**SUBDIVISION &
SIDEWALK WAIVER STAFF REPORT****Date: September 5, 2013****NAME**

Buffalo Marine Service, 14-Baroid Yard Subdivision

309 South Royal Street
(Area bounded by South Royal Street on West, Canal Street on South, Madison Street on North and CSX Railroad on the East)

**SECTION A-A
CANAL STREET**

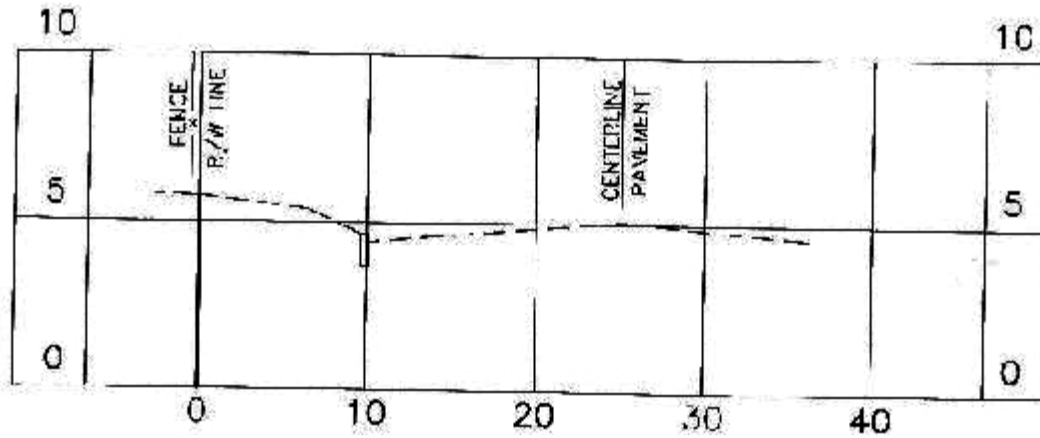
Regarding the Sidewalk Waiver request, the applicant states that there is an abundance of utilities, above and below ground, existing along Madison Street and Canal Street. The applicant also states that Water Street, lying East of the railroad tracks and East of the subject property, currently has no sidewalk and pedestrian traffic along Madison Street and Canal Street is minimal. Furthermore, the applicant states that there are sidewalks that currently exist along the North side of Madison Street and along the South side of Canal Street.

With regard to the applicant's request, not having a sidewalk on Water Street and minimal pedestrian traffic does not negate the fact that a sidewalk is required by the Subdivision Regulations. The applicant states that there are sidewalks that currently exist along the North side of Madison Street and along the South side of Canal Street thus confirming that sidewalks on this site along Madison Street and Canal Street would not be abnormal and would allow connectivity. It appears that there is sufficient area between the utility poles and property for the construction of a 4 feet wide sidewalk. It is always desirable to provide a sidewalk if possible to create walkable environment, even for industrial. However, the City's Engineering Department has stated that due to the industrial zoning and the proximity of the active railroad the sidewalk waiver should be recommended for approval.

Sidewalk Waiver: Based upon the preceding, it is recommended that this sidewalk waiver request be approved along both Madison and Canal Street.
